December 11, 2008

RE: Addendum to License # 10-23967-01E
(for lamps container KR-85)

This is in reply to your letter dated December 2nd, 2008. In the following pages we have tried to answer the questions in your letter to the best of our ability and have attached documentation accordingly.

Copy of etch on lamp(s) and packaging which shows KR-85 documentation.

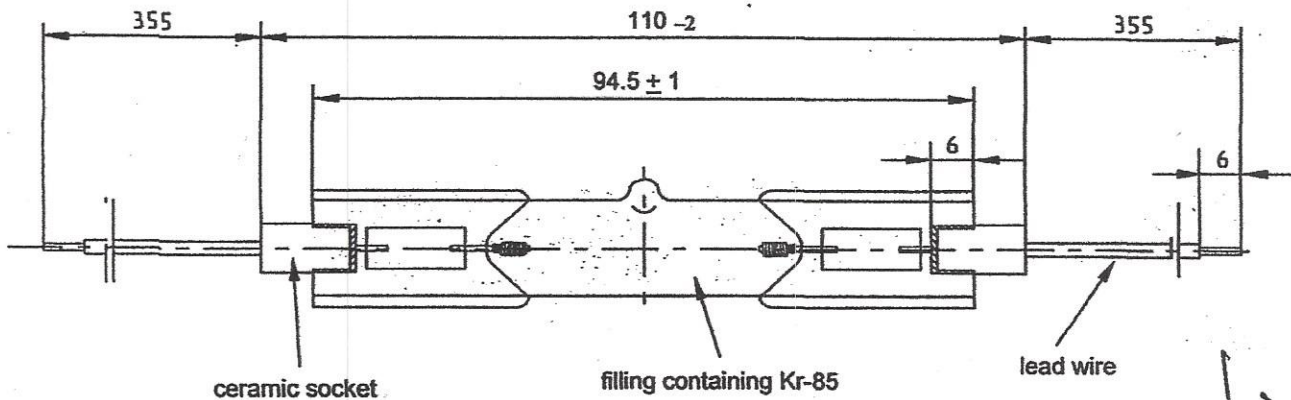
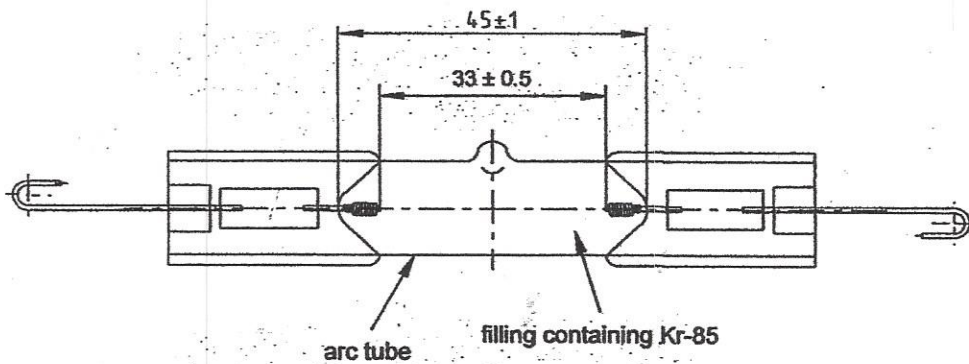
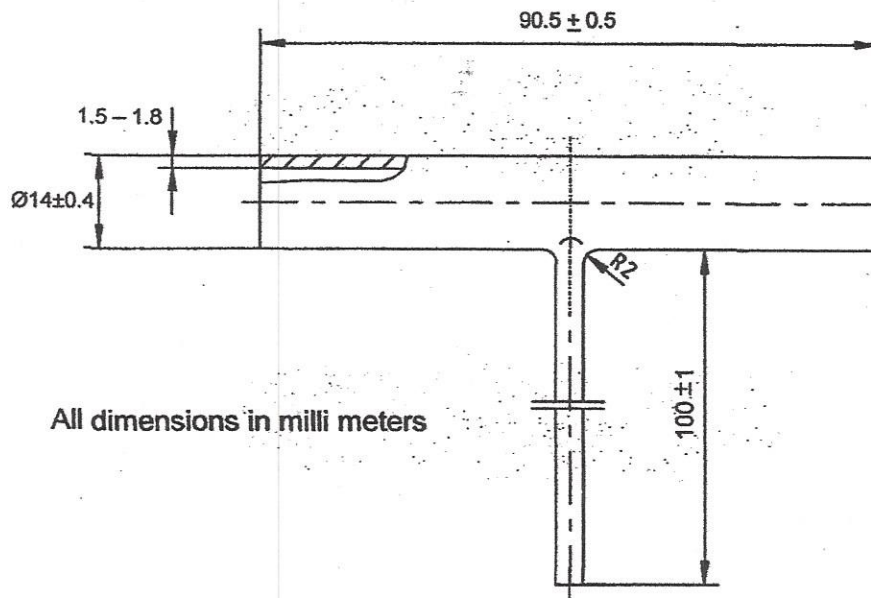
Your letter provided copies of the labels for one model of lamp, but the relationship of these labels to any of the 32 listed lamp types is not clear. Please indicate to which model or series this label applies. If labels for all models / series are substantially the same, this should be clearly indicated in your response.

Please note: These labels apply to all model lamps in the series listed (see sheet attached). All lamps will contain these exact markings as shown. The only thing that will change would be the lamp description (i.e. 1400w 230v) and the part number.

TYPICAL PRODUCT PICTURE:

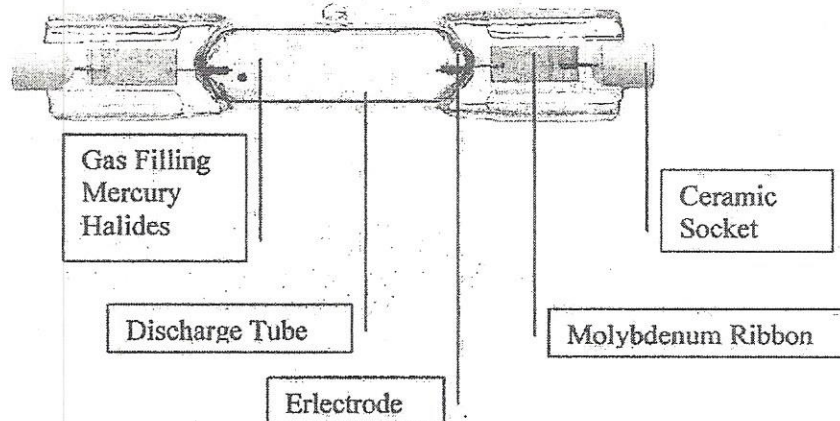
Question 1: Title 10, Code of Federal Regulations, Section 32.14(b)(2) requires details of construction and design of each product. *Your letter dated October 2, 2008, with enclosures, did not fully address this requirement.* Please provide this information for each model that you would like to distribute.

A) Dimensions and thickness of the quartz arc tube and dimensions of the lamp:

Attachment: The Technical Drawing 400 watt, which also states that the lamp contains Kr-85. This is a typical arc tube, quartz burner and the lamp with a socket, the 400watt 230v R7x. This lamp is sold in the USA and is available as follows: 4500SI (7s), 4500WL (wirelead) and 3520PIJK (GY9.5), the parenthesis depicting the type of lamp socket used.

All dimensions on all drawings are in metric in millimetres (mm). And that this pertains to all model lamps in this series containing Kr-85.

The only variable is the length and diameter in each product. And of course description (i.e. 400w 230v) and part number.
